DUQUESNE LIGHT COMPANY

Beaver Valley Power Station

INSERVICE TESTING (IST) PROGRAM FOR PUMPS AND VALVES

Issue 2 Revision 0C

2QSS*P21B
MOP CURVE

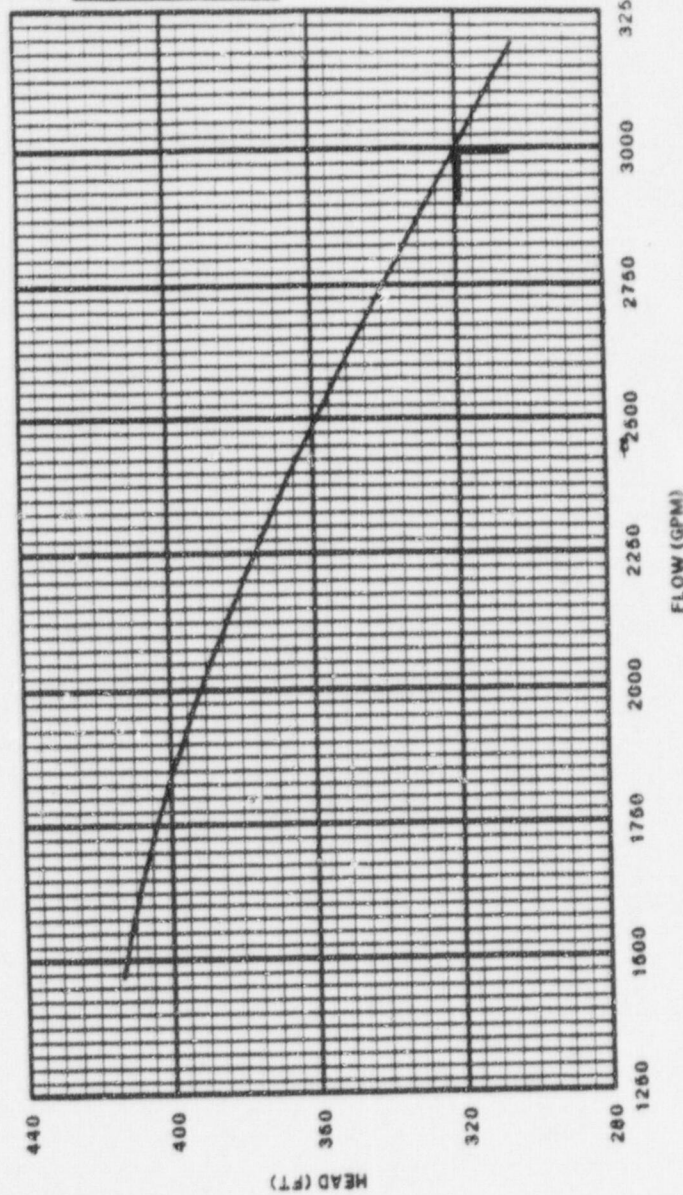
MOP POINT IS AT 320 FT AT 3000 GPM PER CALC
12241-US(B)-193-1 (8/24/89) (REFERENCE
EM 116394 DATED 5/19/98)

DERIVED AS 95.7% OF PUMP PERFORMANCE CURVE
OBTAINED ON 5/11/98.

2RSS*P21A
MOP CURVE

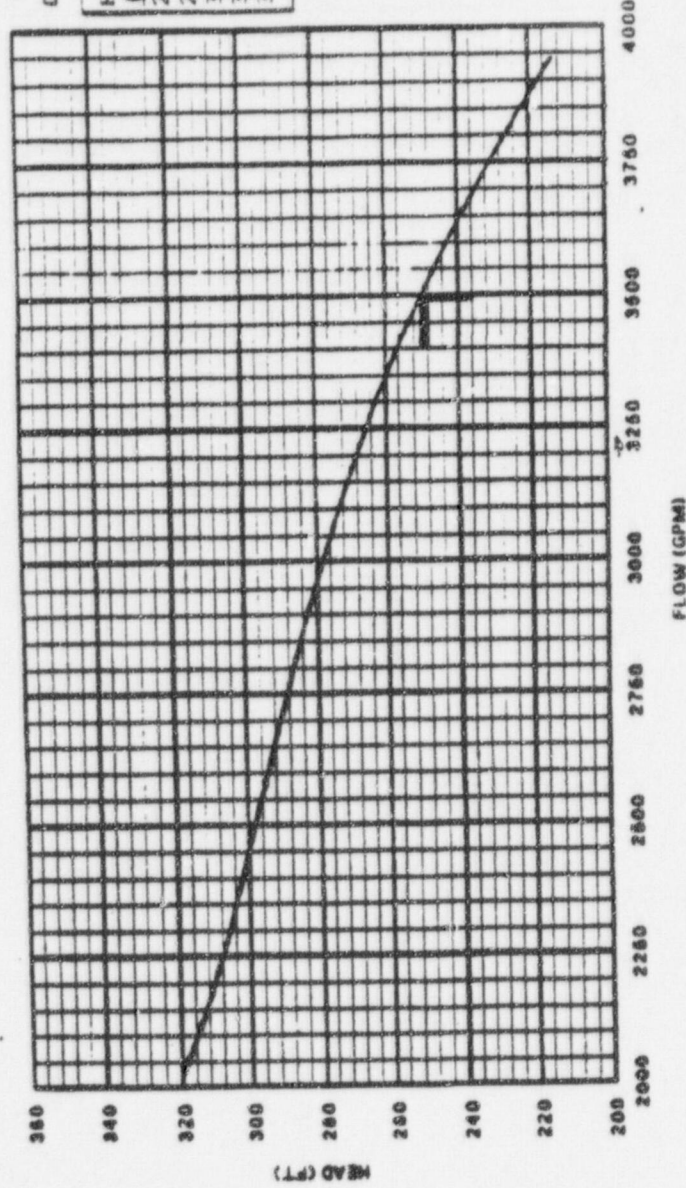
MOP POINT IS AT 250 FT AT 3500 GPM, AND IS BASED ON THE NUMBER OF TUBES PLUGGED IN 2RSS*E21A PER EM 110133 AND CALC 10080-N-724-0 (4/19/95)

MOP CURVE IS DERIVED AS 97.08% OF THE PUMP PERFORMANCE CURVE OBTAINED ON 4/17/98. (CURRENT # TUBES PLUGGED IN 2RSS*E21A) = 26)
